KWM-380 TRANSCEIVER (622-5093-101)
HF-380 TRANSCEIVER (622-3580-101)
RECEIVER-EXCITER CIRCUIT CARD A3 (638-6908-001)

SERVICE BULLETIN NO 1**PRODUCT IMPROVEMENT**

This is a nonmandatory service bulletin which applies to the following:

Power Amplifier A1A1,
After Modification
Figure 1 (Sheet 2)

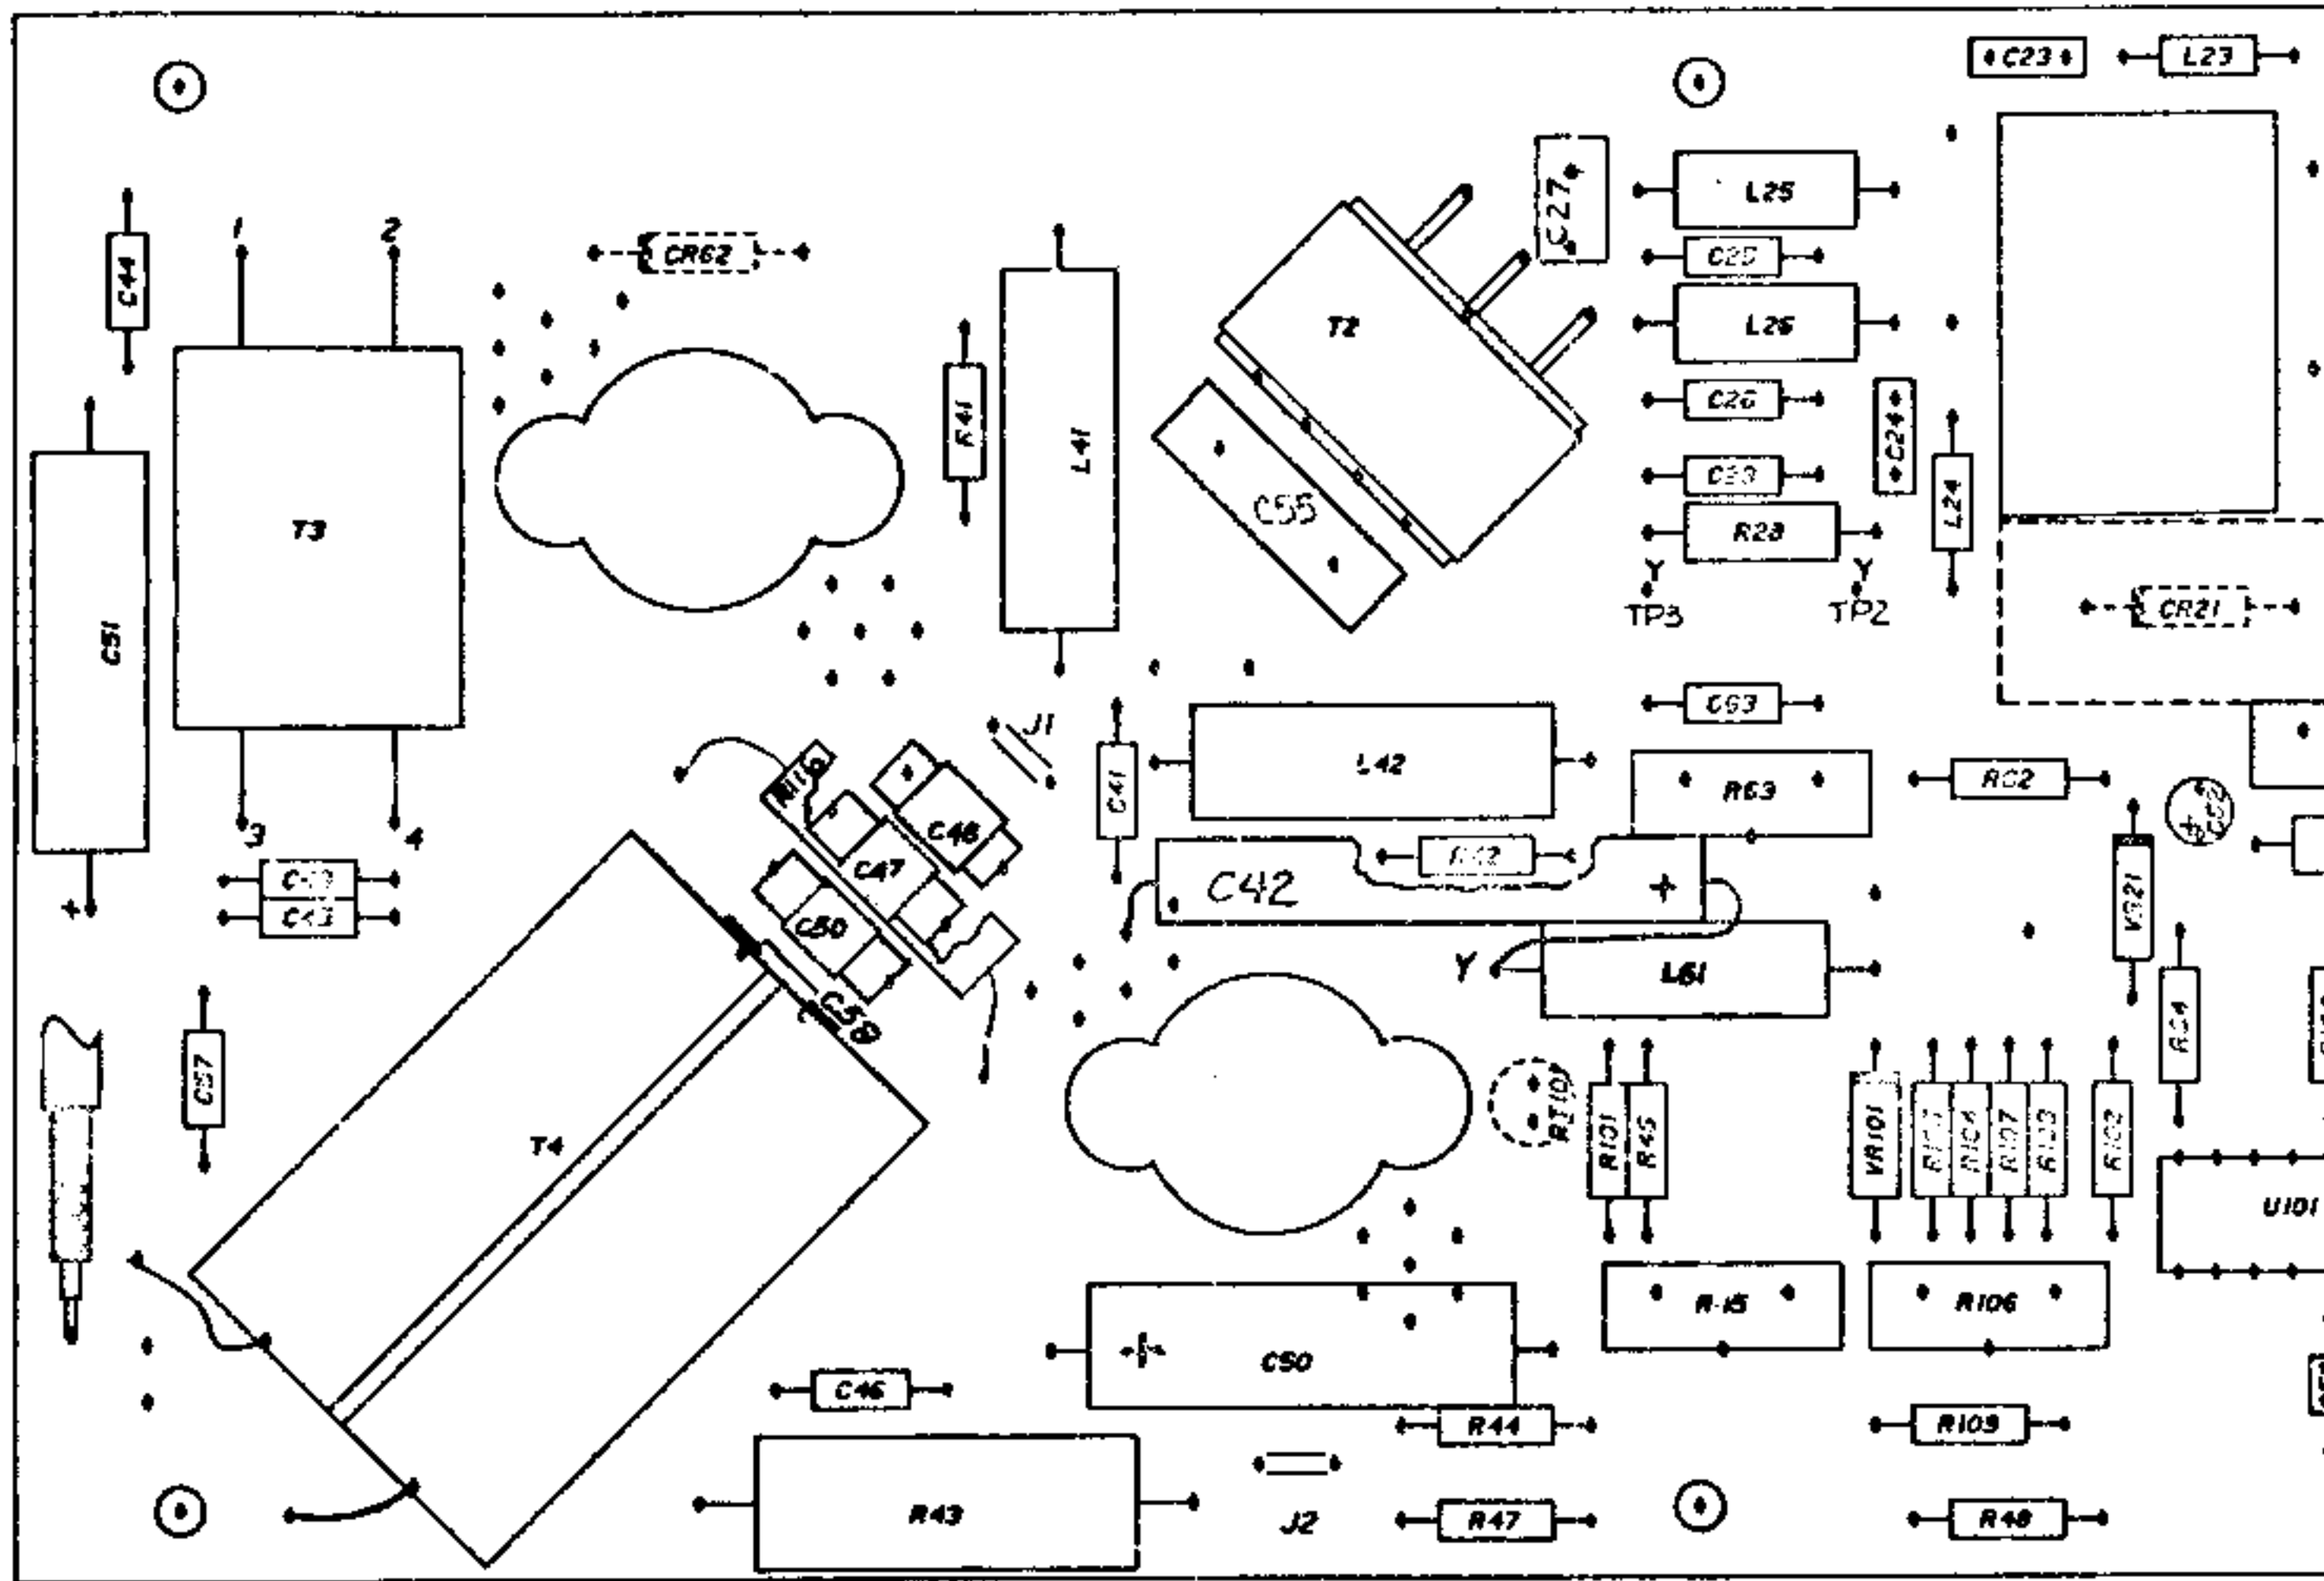
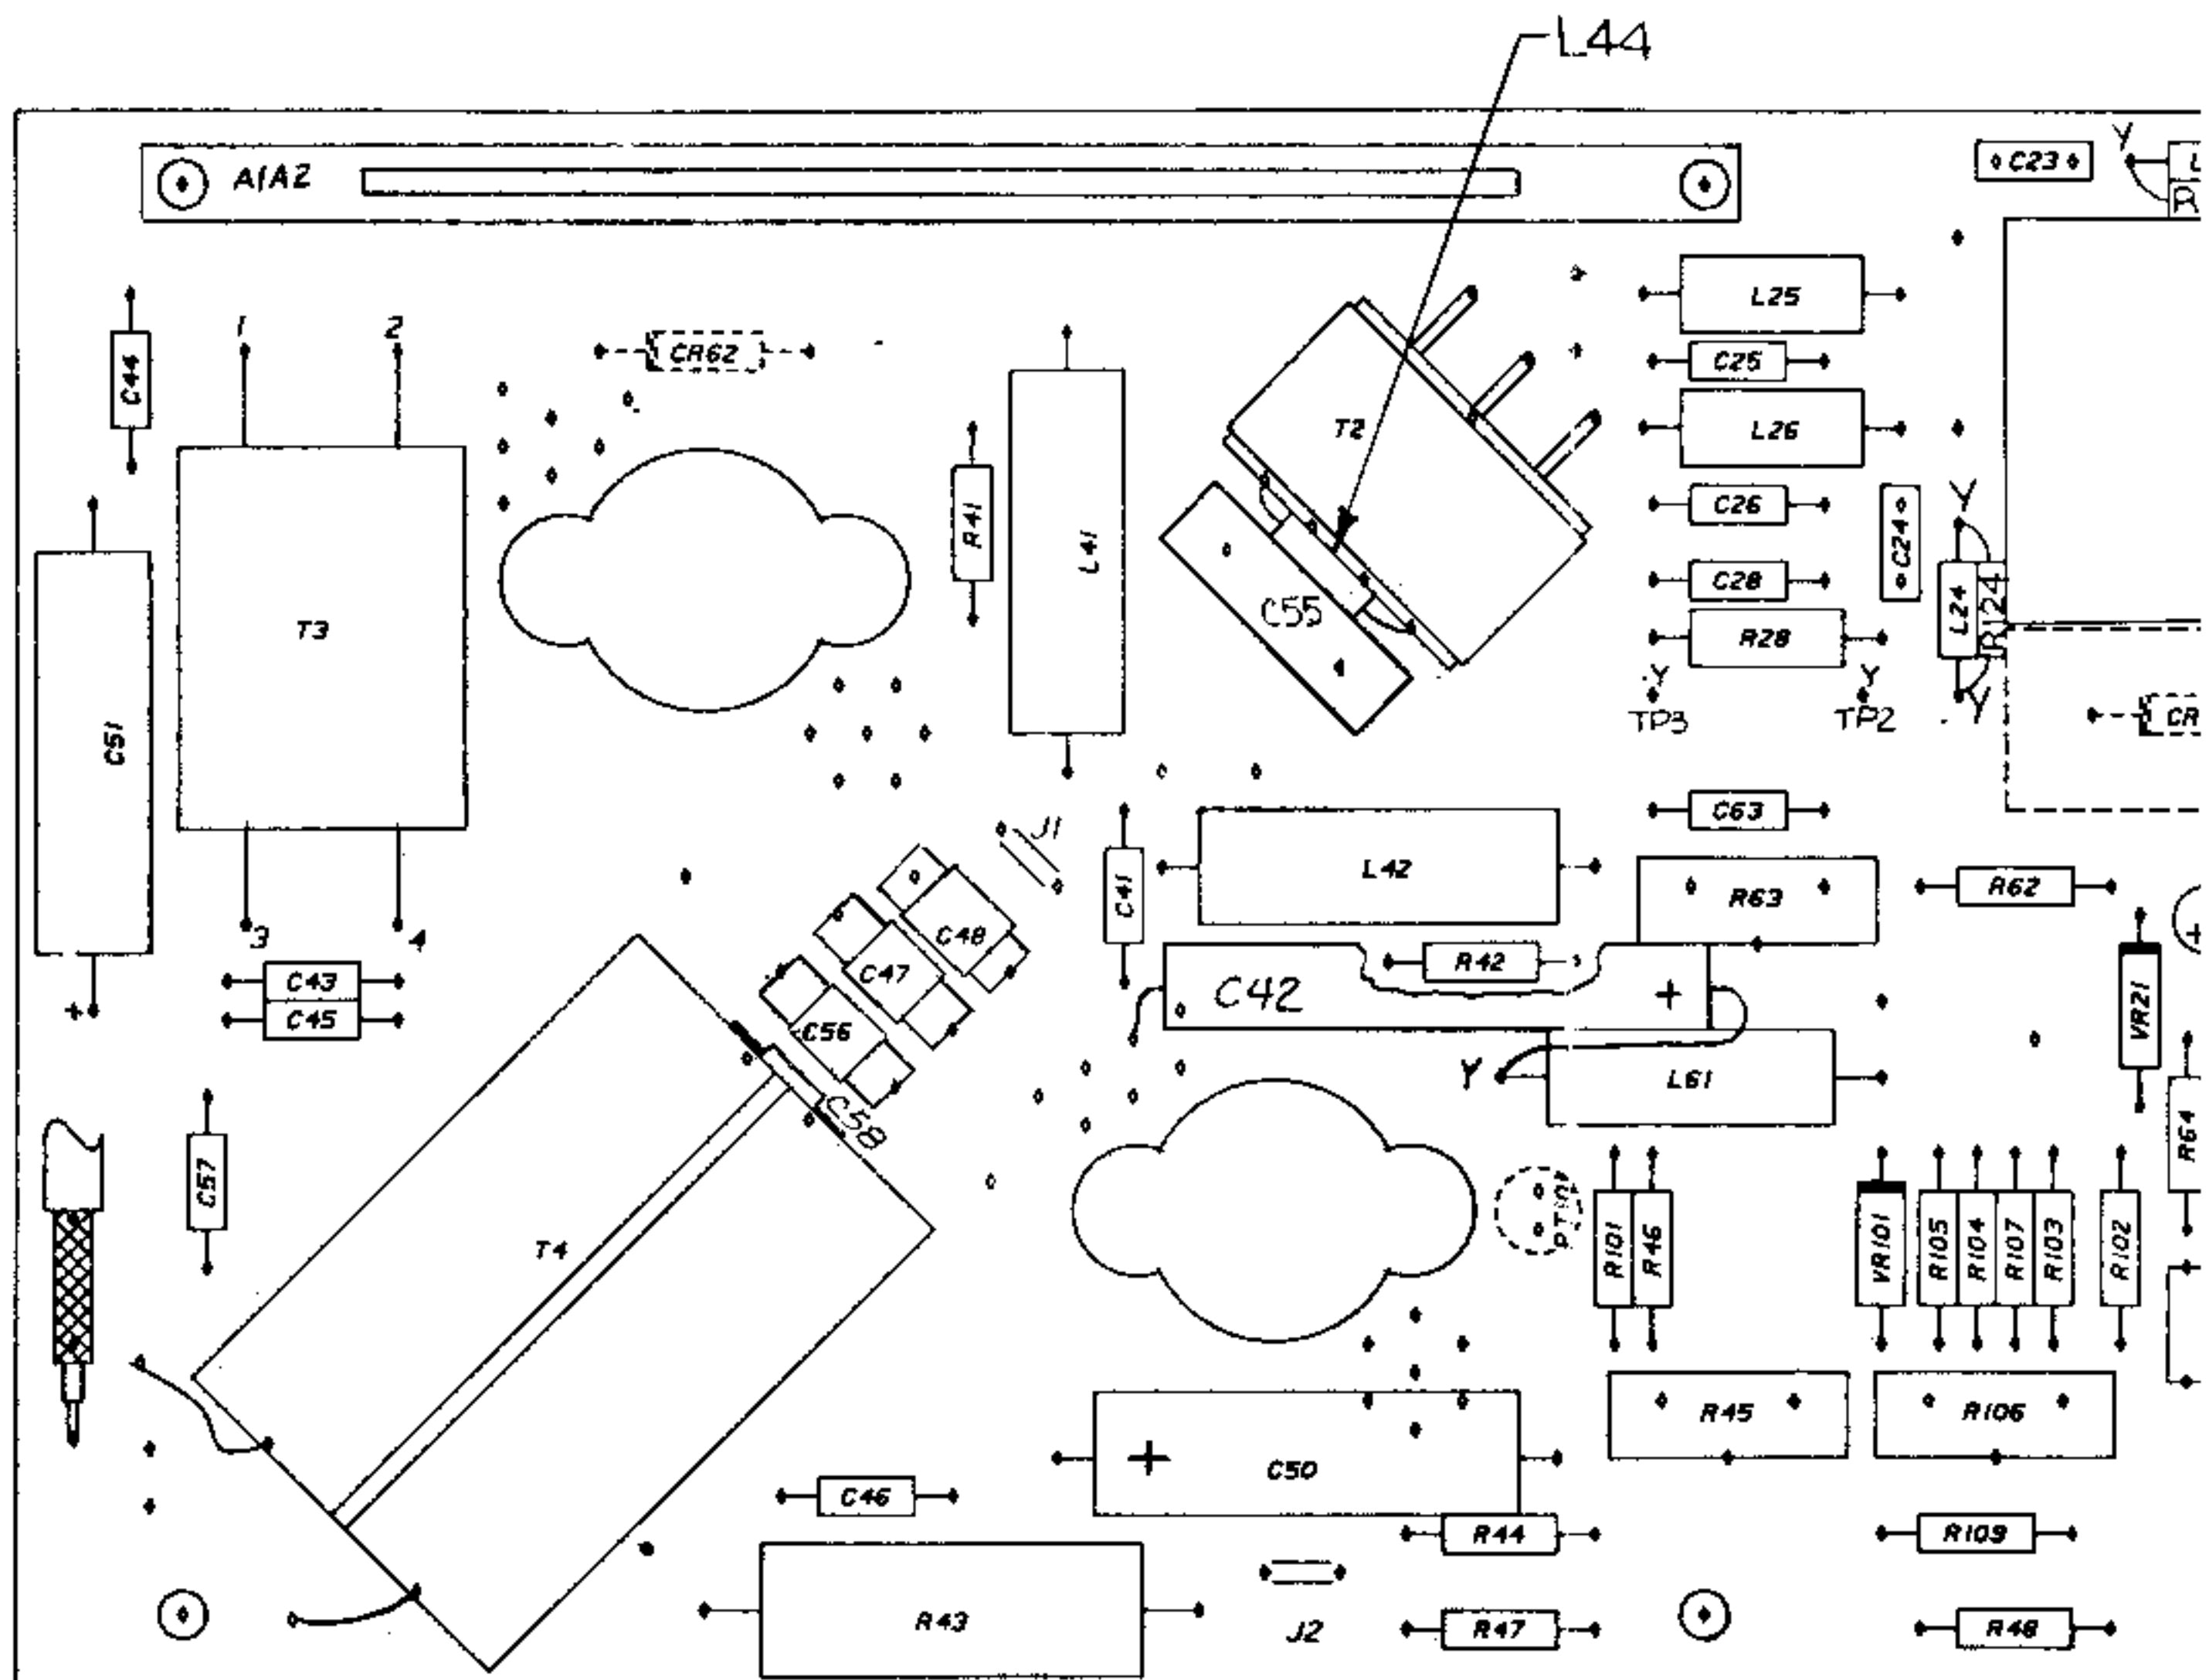
- E. Remove 1500-pF capacitor C55 by cutting the leads close to the body of the component. Leave the capacitor leads soldered into the circuit card.
- F. Install a 1000-pF capacitor (912-3315-000), connecting the leads to the leads of the capacitor removed in step E.
- G. Install a 2.7- μ H coil L44 (240-2715-180) as shown in figure 1, detail A.
- H. Remove 0.27- μ H inductors L23 and L24 by cutting the leads close to the component body. Leave the inductor leads soldered into the circuit card.
- I. Install two 3.3- μ H inductors (240-2029-000), connecting the leads to the leads of the inductors removed in step H.
- J. Install 100- Ω resistor R123 (745-1310-000) in parallel with L23. Wrap the resistor leads around the coil leads and solder.

- K. Install 100- Ω resistor R124 (745-1310-000) in parallel with L24. Wrap the resistor leads around the coil leads and solder.
- L. Examine transistors Q41A/B and resistor R7. If Q41 was manufactured by Motorola, the value of R7 should be 15 Ω . If Q41 was manufactured by CTC, the value of R7 should be 27 Ω . If it is necessary to replace R7, cut the resistor leads close to component body, leaving the leads soldered into the circuit card. Install the new resistor (15 Ω , 745-0683-000, or 27 Ω , 745-0692-000), attaching the leads to the old resistor leads.

- O. Remove 40.2-k Ω resistor R93 by cutting the leads close to the body of the component. Leave the leads soldered into the circuit card.
- P. Install a 44.2-k Ω resistor (705-1075-000) attaching the leads to the leads of the resistor removed in step O.

- Q. Remove and discard 68- Ω resistor R116.
- R. Install electronic components assembly A1A2 (647-2781-001) onto the circuit card as shown in figure 1 using the existing hardware.

- S. Wind two turns of brown wire (422-0795-000) in transformer T3 as shown in figure 1, detail B. Connect to A1A2 assembly as shown in figure 1, detail D. If the transformer core has potting in the holes, carefully clear a way for the brown wire, using a stiff wire such as a straightened paper clip.

- T. Wind two turns of red wire (442-0796-000) in transformer T2 as shown in figure 1, detail D. If necessary, clear the core of potting as in step S.

NOTE: The added wires in steps S and T must be oriented as shown in figure 1, details B and C, to prevent oscillation.
